Mitsubishi Electric AC Servo System

No.22-17E

Change of the Protection Device (Thermal Fuse) for the AC Servo Amplifier Option Battery MR-BAT6V1 Series

Table 1. Details of the change

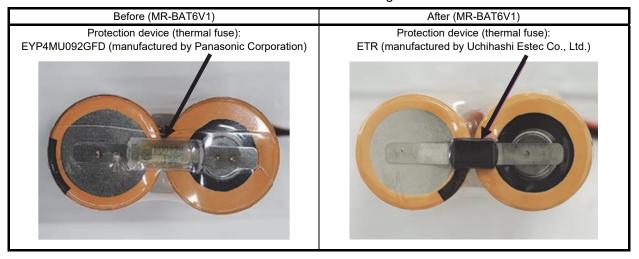
The protection device (thermal fuse) for the MR-BAT6V1 will be changed. This change does not affect the functions and performance of the products.
